# Access Compliance Report

## Public Rights-of-Way

### (Pedestrian Signals)

Intersection ID: N/A	Main Street:	Cross Street: N/A	Location: N/A
ADA ID: 2C687CA13286	Signal Type: One Push Button-Non APS	Overall Compliance: No	Severity Score: BTN 1: N/A BTN 2: N/A No BTN: N/A
Codes/Mitigation Info/Possible Solution		Field Measurements/Component Compliance

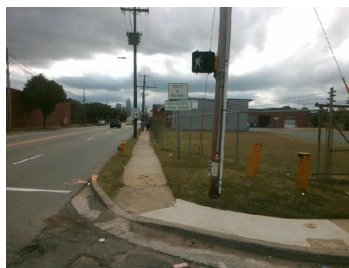
Possible Solutions: Install Sign. Provide Push Button Extension. Remove and Replace Clear Space.

PROW/ADA: R209.1, TMUTCD 4e.08, R404.2, R406.2
